ALERT SERVICE BULLETIN

Replacement of fuel pump assy. for ROTAX® Aircraft Engine Type 915 i A and 912 i (Series)

MANDATORY

Fig. 1

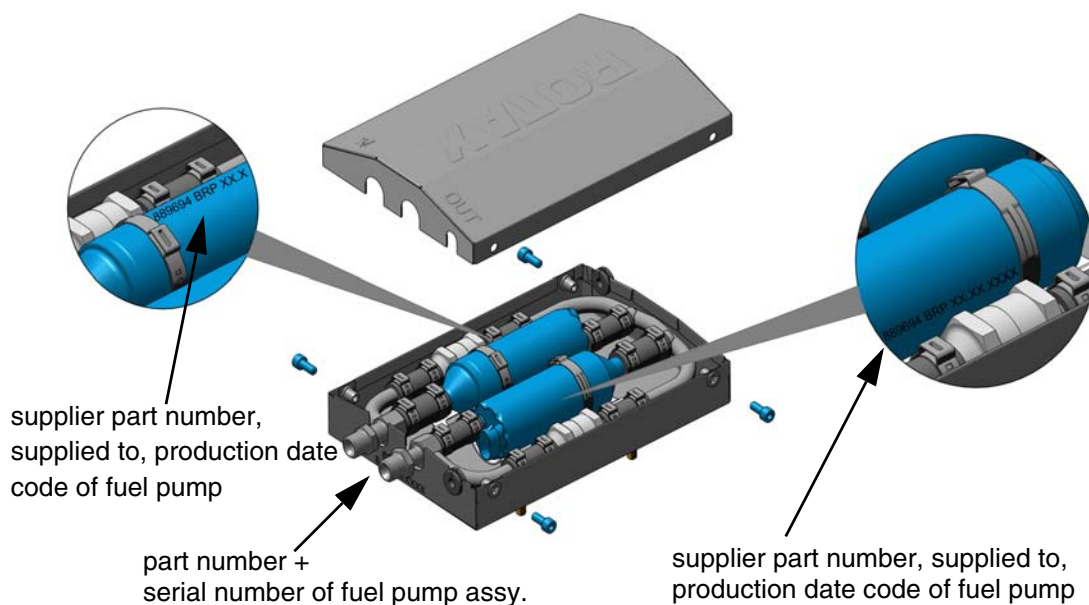
See Fig. 1 for information on how to find the part no. and S/N on the fuel pump assy.
